RE: **Signal Village Condos**
Grading Plan
Engineer's Stamp Date 10/03/17
Hydrology File: C20D077

Based on the information provided in the submittal received on 10/04/2017 the above-referenced Grading Plan cannot be approved for Preliminary Plat, Building Permit, or Grading Permit until the following are addressed:

LOT 16, BLK. 4, TR. 3, UNIT 3
SIGNAL VILLAGE CONDOS
Grading & Drainage Plan
WITH HEC-RAS & USAOE OHWM

REINFORCED CONCRETE MASONRY / SCOUR WALL

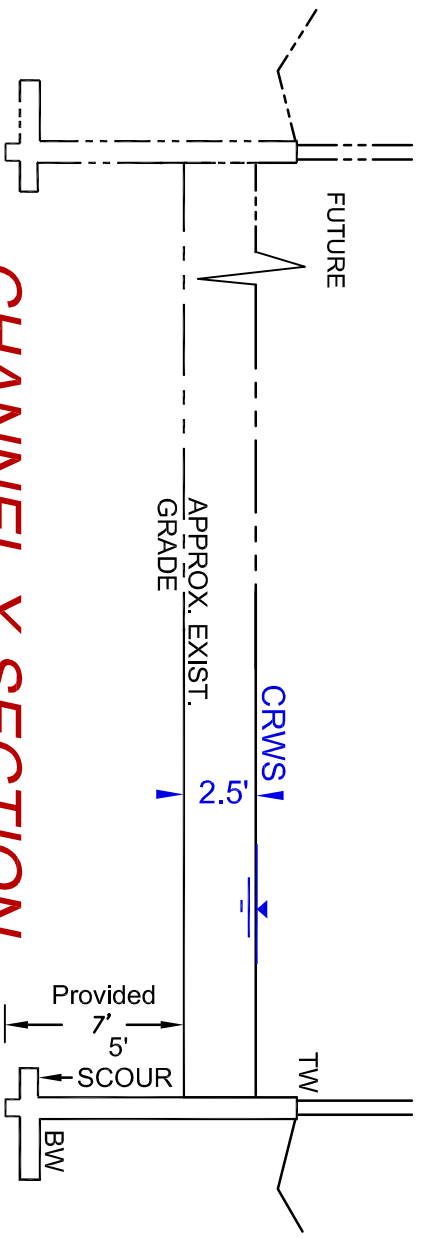
12. Lateral migration of the arroyo must be anticipated. Development is encouraged to stay outside of the Prudent Limit. Any development within the Prudent Limit must be protected from potential lateral migration of the arroyo to the depth of scour calculated in accordance with the "Sediment and Erosion Design Guide". Parallel flow may be assumed over most of the length of the scour wall, but perpendicular flow must be anticipated at the upstream end.

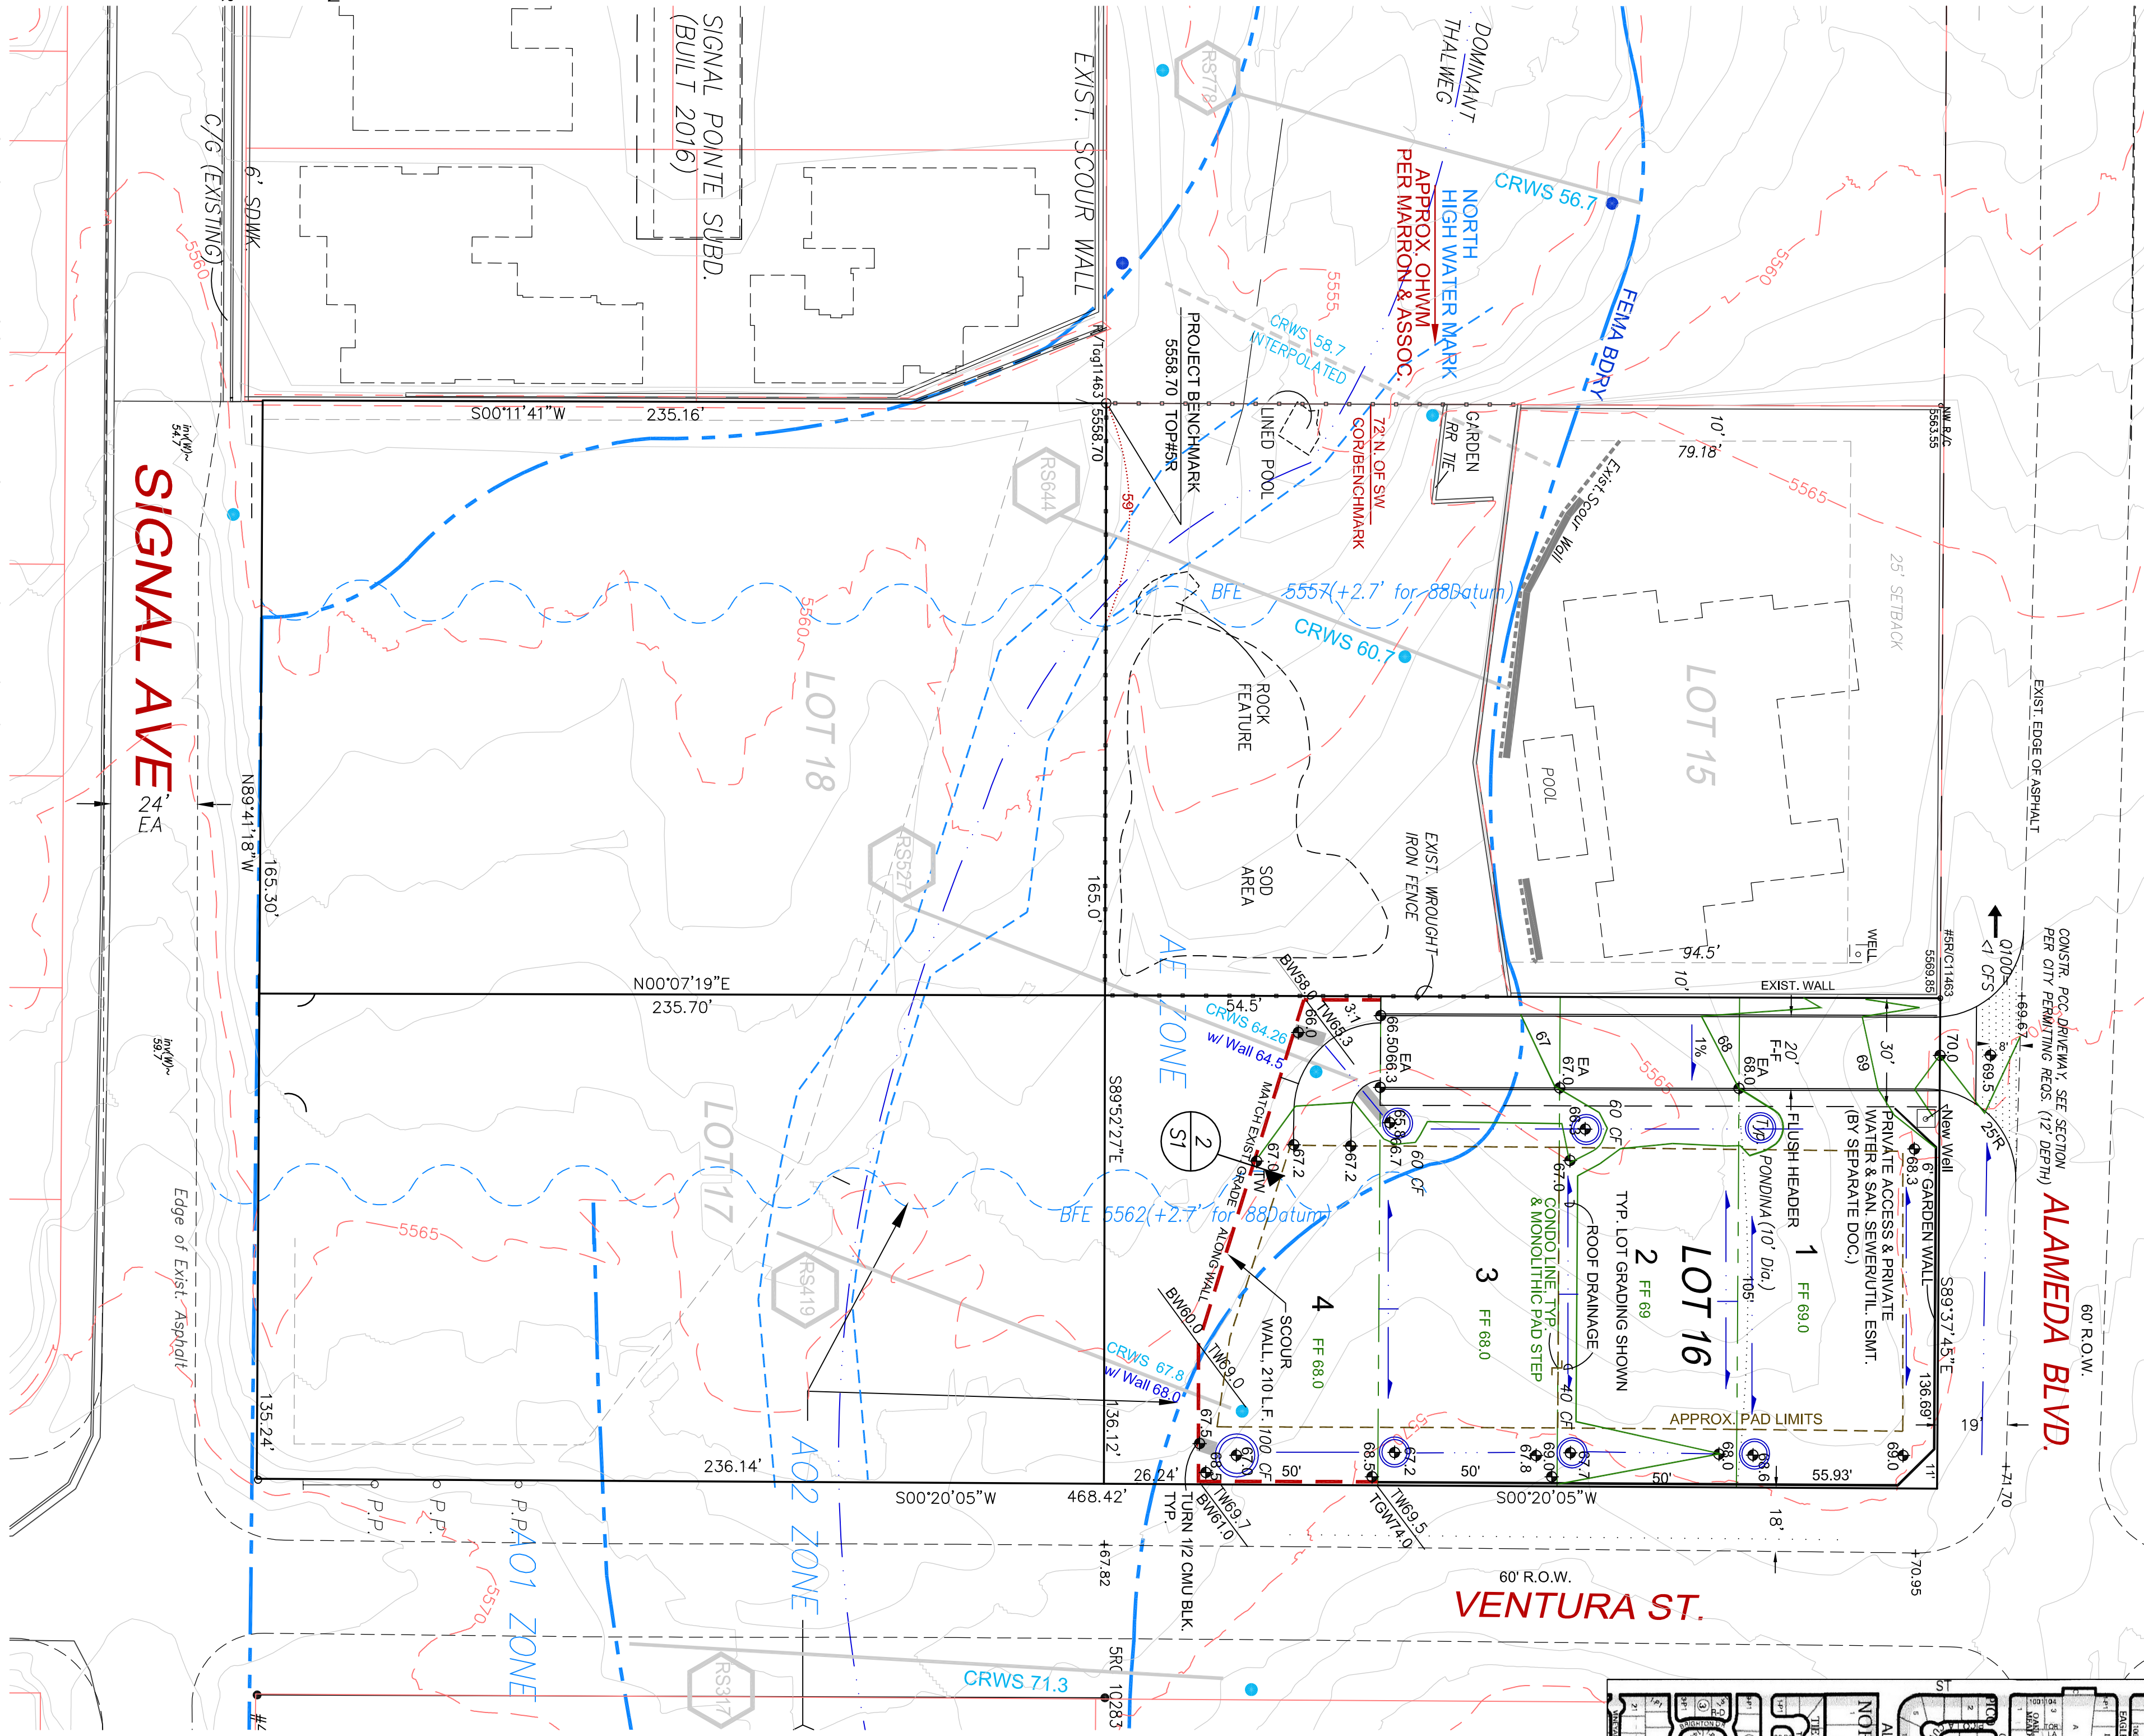
1. According to the La Cueva Sector Development Plan the maximum density is 5 du/(net)ac. Excluding the access easement, this site has about 0.6 acres net. So only 3 dwellings is allowed. Please provide written verification from the zoning administrator that the proposed use is allowed.

2. Is this Condos or Townhouses? The title block says Condos, but the level of information shown indicates a subdivision. If the property is subdivided then the grades on the approved G&D plan must be constructed and verified by an Engineer's Certification prior to allowing Building Permits on the individual lots. If this G&D Plan is for a subdivision then delete the word "Condo" from the title and indicate "Preliminary Plat Approval" instead of "Building Permit Approval" on the DTIS form. But if it is a Condo, the building footprints, floor elevations, patios, porches, sidewalks, driveways, etc. must be shown on the Grading Plan prior to approval for Building Permit, then the Engineer's Certification will be required prior to Certificate of Occupancy.

4. Frontage improvements will be required on Ventura St. and Alameda Blvd. that must be shown on the G&D plan. Typical sections must be shown on the G&D Plan for all roads both onsite and offsite. The sections and the plans should show both the full

planned width and the portion to be constructed with this project, along with any temporary transitions at the ends.

5. Upstream offsite flows enter this site near the intersection of Alameda Blvd. and Ventura St. Analysis of that drainage must be included in this project demonstrating compliance with the DPM. A basin map is required showing existing contours, topography or aerial photo, flow arrows, and slopes. The receiving facilities must be designed for developed conditions in the upstream offsite watershed. Storm drain may be required if surface drainage capacity is exceeded.

6. Improvements may also be required about 500' east of Ventura on Alameda to prevent split flow at that arroyo crossing. Analysis of existing conditions at that crossing is required and should be based on a detailed topographic survey and analysis to insure that no split can occur that might impact this development.

7. Typical sections are required at all retaining walls at the point of maximum retainage showing existing ground, proposed grades, lot lines, and dimensions. Wall footers must not encroach into public right of way or adjacent properties without a written agreement from the adjacent land owner.

8. First Flush pond details are required. The basins draining to each pond must be identified on a basin map and the required volume calculated for each basin. Then grading details, plans, and sections must be included on the G&D Plan along with volume calculations for each pond. A fee in lieu of construction may be paid to the City for any deficit in the required volume. The first flush volume from all impervious surfaces must be accounted for including new streets.

9. What is a "Monolithic Pad"? Is it a concrete slab or is it a dirt pad?
10. The location of the FEMA floodplain and related information is not shown accurately on this G&D Plan or on other recent plans, Signal Point and 9000 Alameda. FEMA's location must be accurately shown on this plan and a note should be added referring to the effective date and FEMA file number. The FEMA thalweg and sections should also be shown.

11. Fill in the flood plain, if applicable after floodplain location correction above, must be justified by hydraulic analysis demonstrating no increase in the adjacent flood plain elevation. The analysis must include HEC-RAS models of the "Duplicate Effective", "Corrected Effective", and "Revised" flood plains, beginning with the model acquired from FEMA thru a data request.

13. A plan and profile of the La Cueva arroyo is required showing stationing along the FEMA thalweg and station information for the proposed floodplain improvements.

The profile and a typical section should show the scour depth measured from the existing arroyo invert elevation, and 2' of freeboard above the 100-year base flood elevations.
